Council Bill No. B 162-13

rezoning property located on the south side of Conley Avenue, between Fourth Street and Fifth Street, from R-3 to PUD-90; approving The Residences at Fifth and Conley PUD Site Plan and setting forth a condition for approval; approving the statement of intent; repealing all conflicting ordinances or parts of ordinances; and fixing the time when this ordinance shall become effective.

Re: Collegiate Housing Partners, LLC request for rezoning from R-3 (Medium Density Dwelling District) to PUD 90 (Planned Development 90 units/acre) (**Case # 13-79**)

PUD SITE PLAN FOR THE RESIDENCES AT FIFTH AND CONLEY

Case 13-79: PUD Development Plan Collegiate Housing Partners, LLC

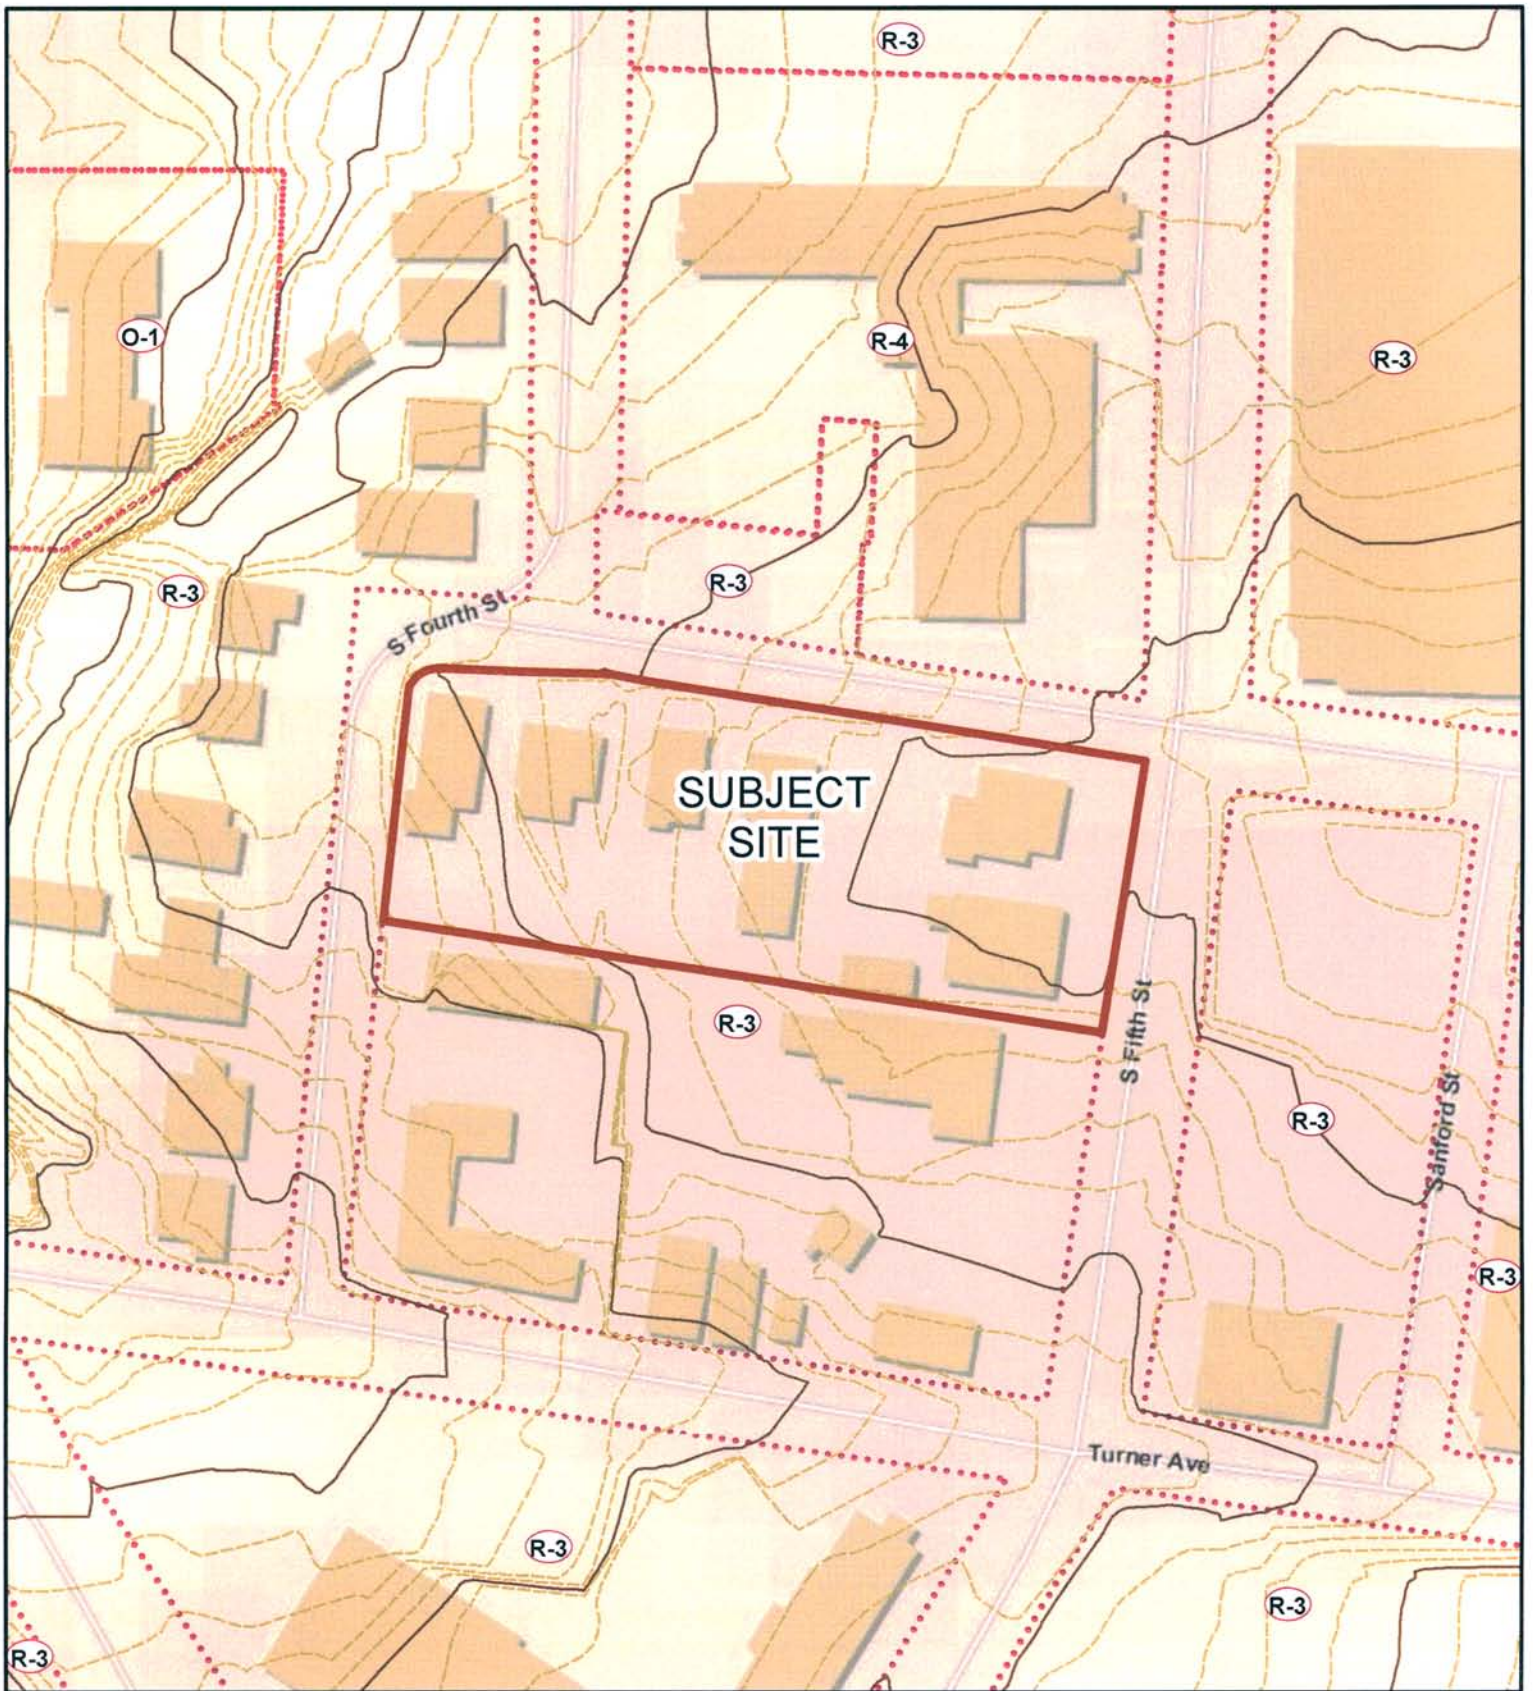
The applicant prepared a traffic impact study that has been reviewed by the City's Traffic Engineers. Based on staff review, the site plan has been modified from its original submission to:

- a) Provide required half-width upgrades on all adjacent streets
- b) Show an increase in the pavement width (to 28 total feet) on 4th Street and Conley Avenue which will ensure compliance with the "residential" street standards and offer the opportunity for potential on-street parking.
- c) Provide a 10-foot sidewalk along 5th Street and 6-foot sidewalks along 4th and Conley Streets. The sidewalk width on 4th Street and Conley Avenue, while smaller than requested by staff, is the maximum possible based on upgraded right-of-way and additional pavement width. Sidewalks will be located along the back of the curb which is typical in the C-2 District.

There are additional traffic study comments that have not been addressed through the revised site plan which require additional analysis by the Traffic Consultant. The staff's traffic study comments and the study itself attached. The outstanding comments can be addressed prior to the final plat approval or issuance of building permits.

The applicant is seeking no setbacks along the front and side property lines and a four-foot setback on the rear property line. The establishment of the proposed setbacks would permit this site to develop in a similar fashion to other urban lots within the C-2 district. The purpose of the perimeter setback for a PUD is to provide landscaping and buffering from less intense development similar to that surrounding the subject site.

Considering the applicant has upgraded all the adjacent roadway half-widths and will improve the pavement width on 4th Street and Conley Avenue to meet the "residential" street standards, it is not possible to obtain the required 25-foot perimeter setback. Staff finds that the provided upgrades and future urban frontage that will be created are not undesirable in this location. The development plan clearly identifies a building envelope which, by default, creates setbacks.

Concern exists; however, that the existing tree canopy along the southern property line will be eliminated further increasing the impact on adjacent residential uses. Furthermore, the setback proposed along this property line is questionable in its width to permit the replacement landscaping. Landscaping along this property line should consist of materials that, upon planting, will assist in reducing the visual disparities between the existing and proposed development and will, within four growing seasons, provide substantially similar screening that exists today.
